Revision to P.U.D. # 05-0354

PUD & MASTER DEVELOPMENT PLAN  
LAURA HEIGHTS  
BEXAR COUNTY, TEXAS

# City of San Antonio, Texas

**SUBJECT:** PUD# 05-035A, Laura Heights

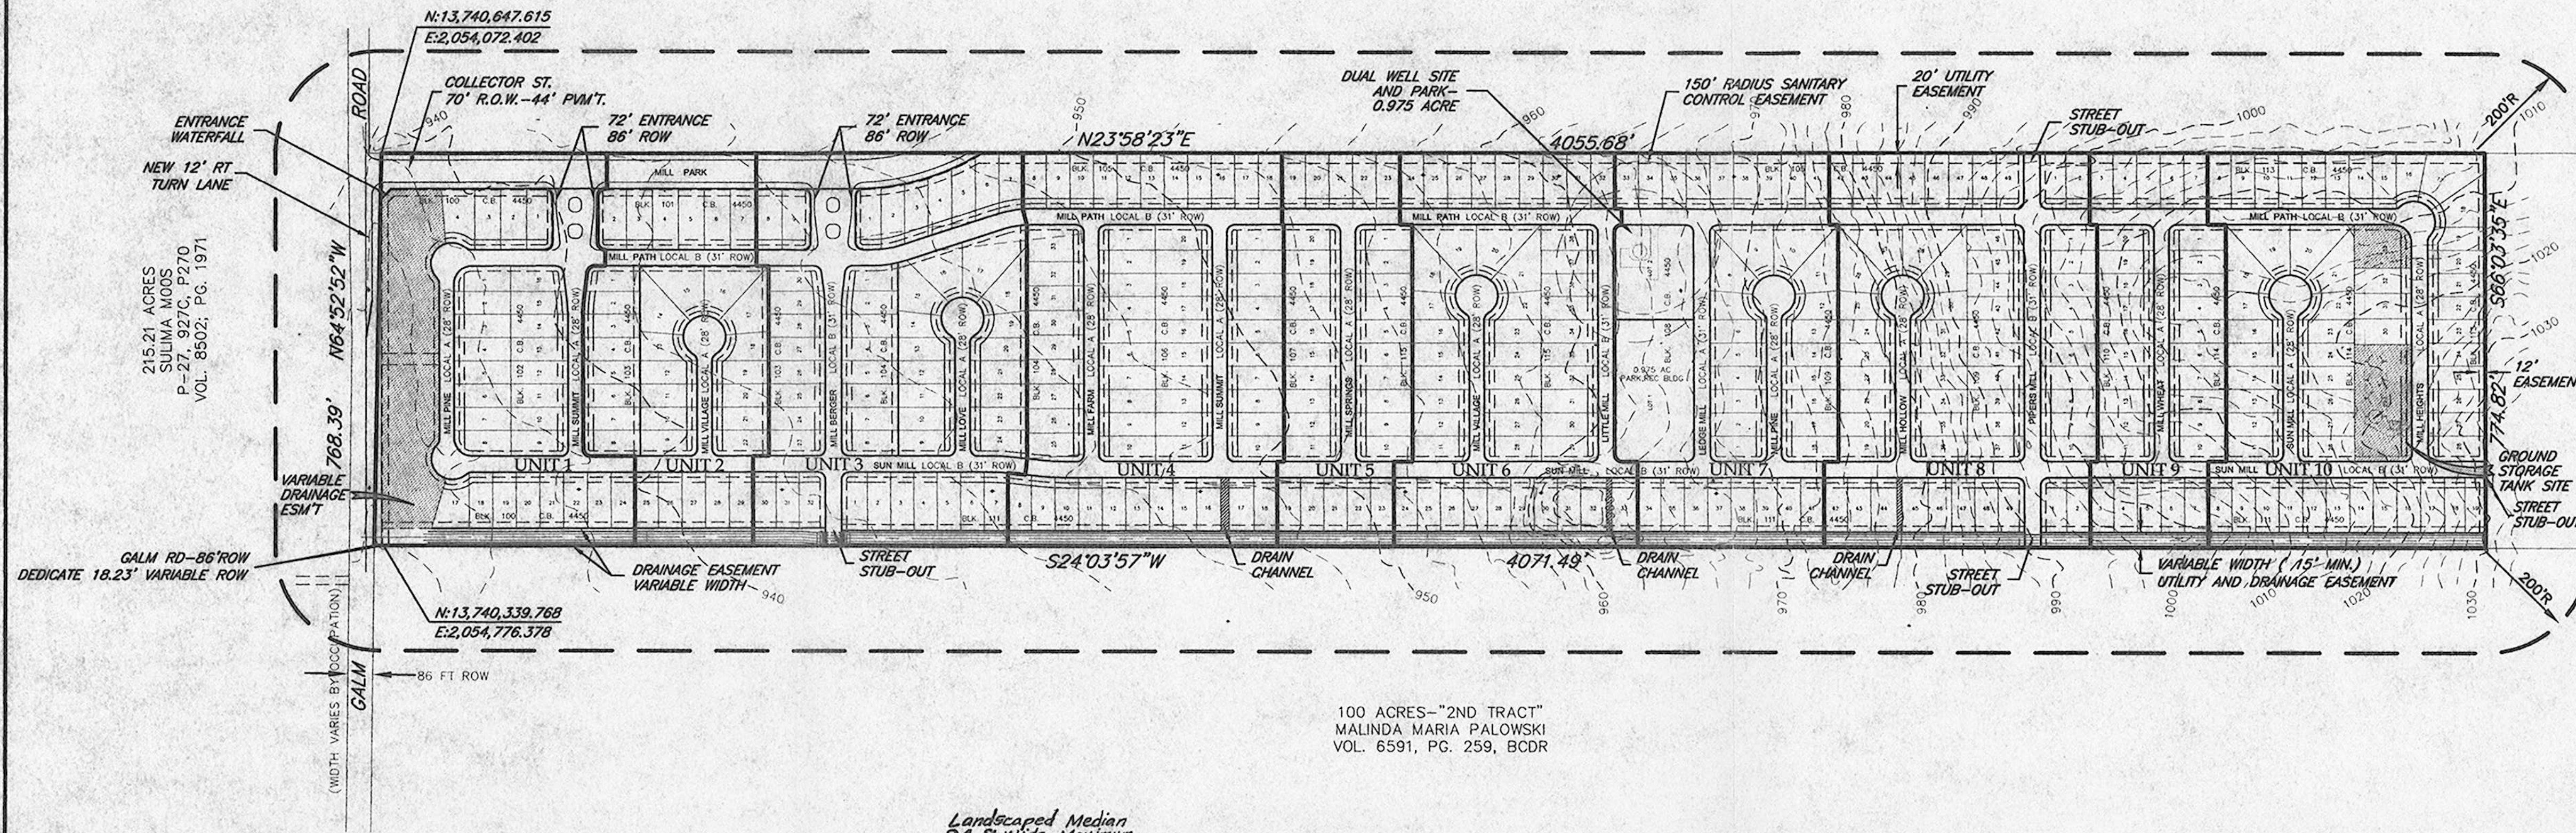
The dedicatory instrument(s) (Legal Instrument) for common areas and facilities must be approved by the City Attorney as to legal form prior to any plat recordation and shall be recorded at the same time as the plat. UDC 35-344(i)

- The Texas Site Atlas indicates that no archaeological sites have been previously identified within the above referenced property. However, the project area is

may contain sites, some of which may be significant. Thus, before any work that might affect any sites is begun, we recommend that a qualified professional conduct an archaeological investigation of the property

- All access roadways shall provide clear sight distance on all existing and proposed roadways in order to provide adequate obstruction free viewing distances for approaching traffic. All signage, landscaping, and improvements shall be selected and located so as to not block these clear sight distance areas.
- The developer shall be responsible for providing right-turn deceleration lanes as well as left turn lanes, with storage lengths and bay taper for Galm Road as it relates to the submitted TIA traffic counts, (Uniform Development Code (UDC) – 35-502(a)(7), subsection C.
- Sidewalks along all interior and exterior roadways are to be installed in accordance with UDC 35-506(q).

- Playground
- Swimming Pool (2,500 sq.ft.)
- Recreation Center
- Athletic Courts

- Secondary access onto the public collector must be secured prior to the approval of any plat or combination of plats exceeding 125 dwelling units.
- All decorative structures shall be placed within private property and not within public right-of-way.
- All traffic controls shall be warranted as per the Texas Manual on Unified Control Devices and approved by Bexar County.
